RE: Proposed Photovoltaic System, 200 Haynes Street, Response to Peer Review, Fire Department & Public Comments

BSC Group, Inc. (BSC) has reviewed the comments provided by CMG, as contained in correspondence to the Sturbridge Planning Board, dated November 1, 2023. In addition, this letter also provides responses to comments received from the Sturbridge Fire Department and the Sturbridge Retirement Co-op. The original comments are shown below and the Applicant's responses follow in bold font.

Peer Review Comments from CMG

Subject: Statement about modules' reflection

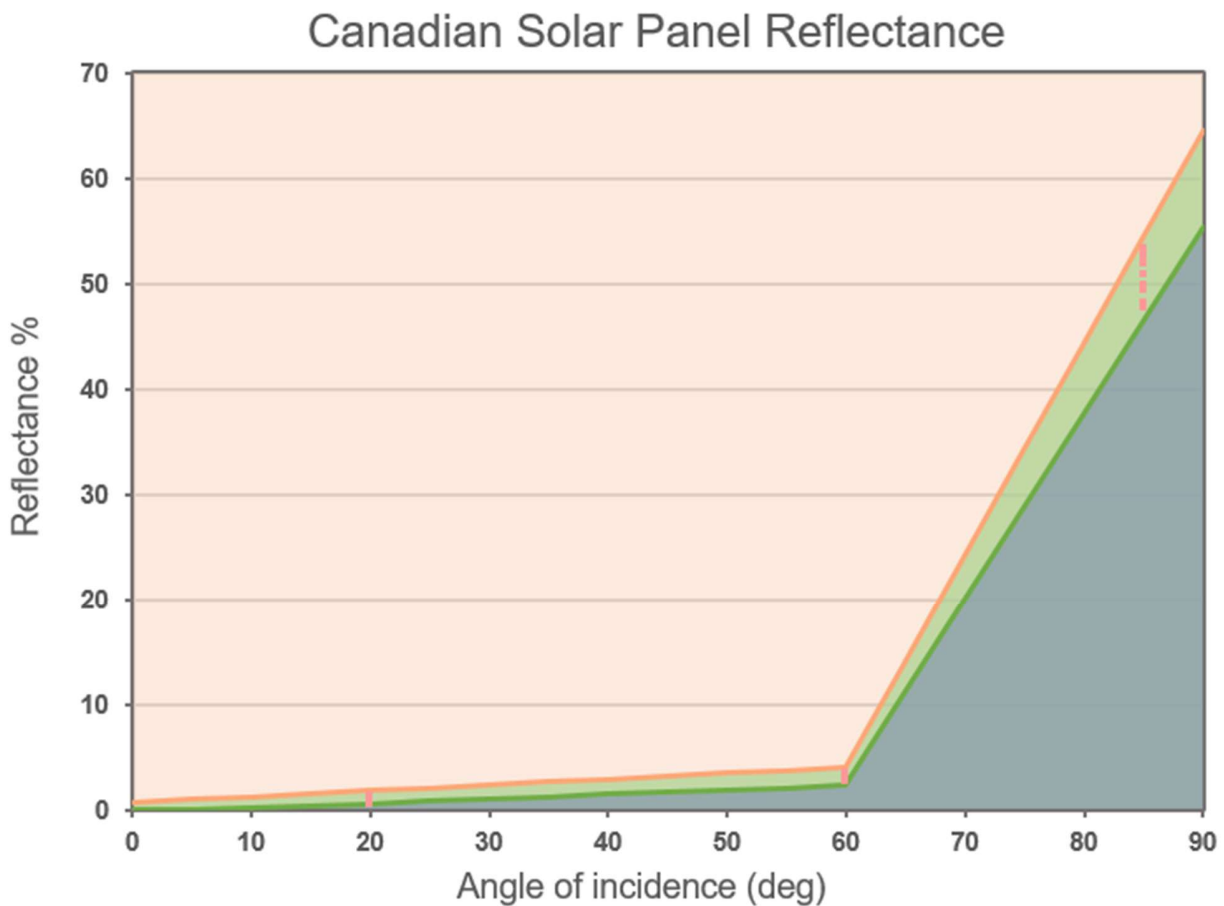
28. §300-10.3.B.(4) – Applicant proposes to utilize an anti-reflective coating on the solar panel's front glass to mitigate glint and glare. Applicant should provide manufacturer's specifications indicating the specific properties of the anti-reflective coating to document there will be "no" glare. Otherwise, CMG recommends a glare analysis be provided.

Please see the attached letter which specifies the glare/reflection required by the manufacturer.

Reflectance is dependent on incidence angle, and becomes very high at large incidence angles (see below picture for reference, test results from CSI CPTL Lab refer to ISO 2831:1994, the standard module reflectance of CSI is likely to plot in the light green area).

Canadian Solar uses “high-transmission low-iron” glass in our solar modules, and narrow down the accepted range of glass surface roughness. This type of glass transmits more light, producing less glare and reflectance than normal glass. This high-transmission glass meets the military’s reflectance requirement, where this value has to be less than 10%. Canadian Solar declares that Modules produced using antireflection coated solar glass have a reflectance value below 5% when with up to 60° angle of incidence.
